WYONG SHIRE COUNCIL

**Wyong Temporary Desalination Plant - Budgewoi Beach**

<b>Applicant:</b>	Wyong Shire Council
<b>Owner</b>	Crown Land (NSW Department of Lands)
<b>Application No</b>	1665/06
<b>Description of Land</b>	Lot 7076 DP 755266
<b>Proposed Development</b>	Temporary Desalination Plant
<b>Site Area</b>	Compound area 1,200m <sup>2</sup>
<b>Zoning</b>	6(a) Open Space and Recreation
<b>Existing Use</b>	Coastal Reserve adjacent to beach car park

This Planning Report has been prepared by Maunsell Australia Pty Ltd on behalf of Wyong Shire Council to independently assess the development application for the proposed **Budgewoi Beach Temporary Desalination Plant**. This assessment has been prepared in accordance with Part 4 of the *Environmental Planning and Assessment Act 1979* (EP&A Act).

*Soft Engineered Geobags protecting a discharge pipe at Maroochy, Queensland*

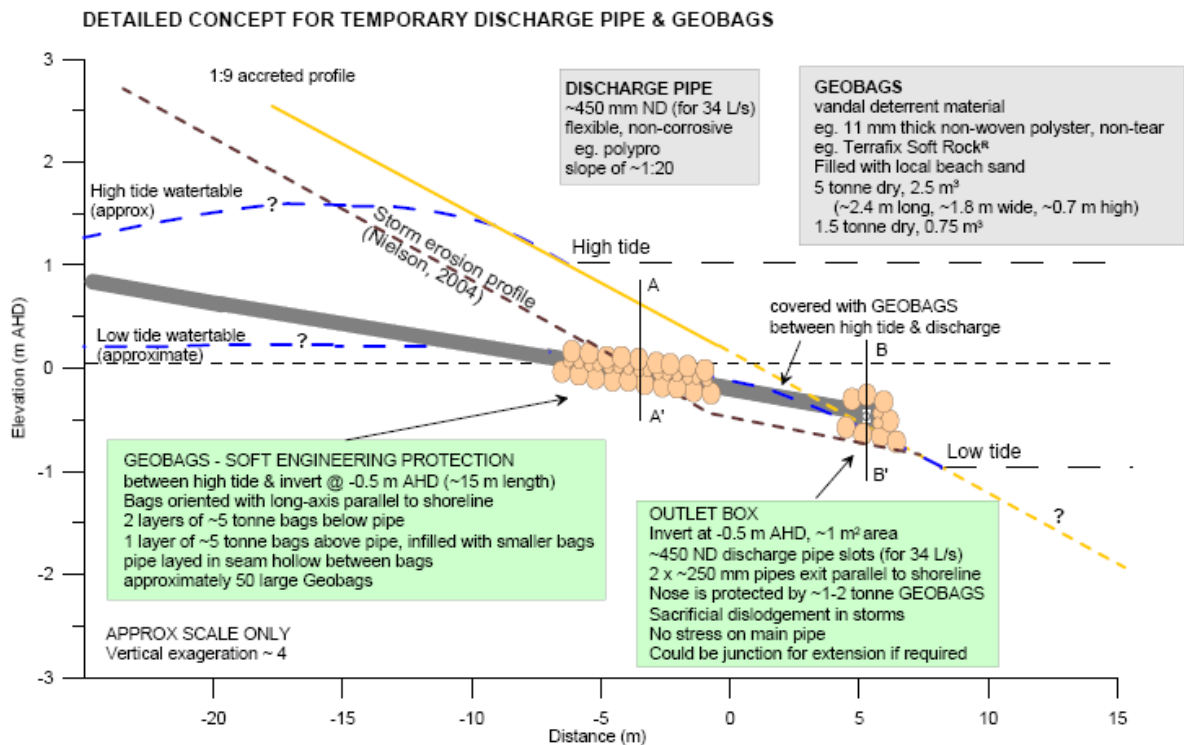
Establishing a seawater outfall above the beach profile will generate a negative impact on the visual landscape by interrupting what is now a continuous beach foreshore. However, due to the temporary nature of the proposal and the community benefit from augmenting water supplies, the detrimental impact generated by the proposed outfall infrastructure is considered reasonable. This assumes that the seawater discharge infrastructure is to be completely removed upon cessation of operations.

In extreme storm events, there is potential for the seawater outfall infrastructure to be further exposed. Reference is made to Figure 4.1 (reproduced below) of the design report (UNSW Water Research Laboratory, 2006), which demonstrates the extent to which the geobags may be exposed if a severe storm causes significant erosion.

Reference to Figure 4.2 of the same report (reproduced below) shows an outfall structure height of around 0.5 m. In reality, if Terrafix Soft Rock products are used (0.75 m<sup>3</sup> bags are 400 mm high, 2.5 m<sup>3</sup> bags are 650 mm high) an overall structure height of around 2.3 m could be expected. After a significant erosion event, this structure would represent a significant physical and visual barrier on the beach. The 5T bags (using Terrafix “Soft Rock” dimensions are 1.8 m \* 2.4 m \* 0.65 m high – around 2.5 m<sup>3</sup>, accounting for curvature on edges).
